Customer Satisfaction Program

16038 Transmission Oil Cooler Line in Contact with Body Stud

Reference Number: N162051960

Release Date: January 2017
Revision: 00

4673806

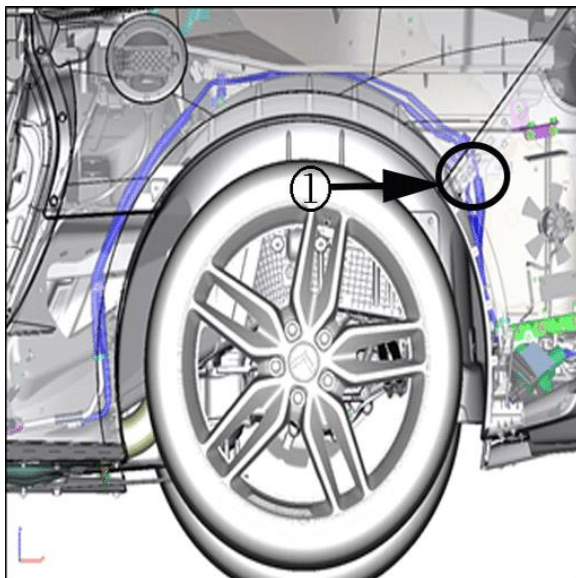
3. Locate the area of the transmission fluid auxiliary cooler inlet rear intermediate pipe that is being serviced (1).
